Applicant : BROWN, RICHARD Page 9  
Serial Number : 10/690,808  
Amendment in Response to Office Action of 07/18/2005

## REMARKS

FIG 7

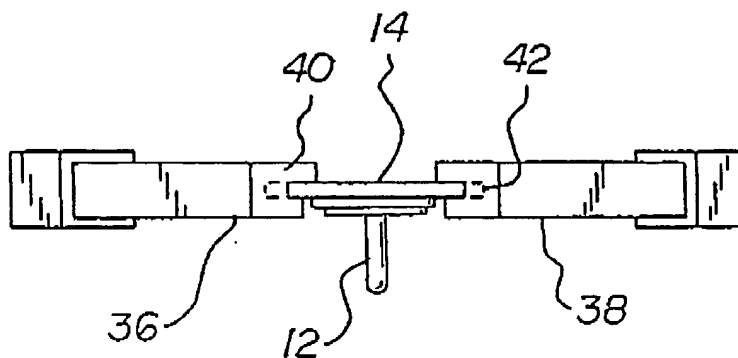
Lastly, the drawings have been amended herein by the elimination to Figure 8 directed to the drive shaft providing the motion and timing to the air cylinder. The specification has been amended beginning at Page 9, Line 13 by deleting the paragraph relating to Figure 8.

## Annotated Drawing Showing Amendments in Red
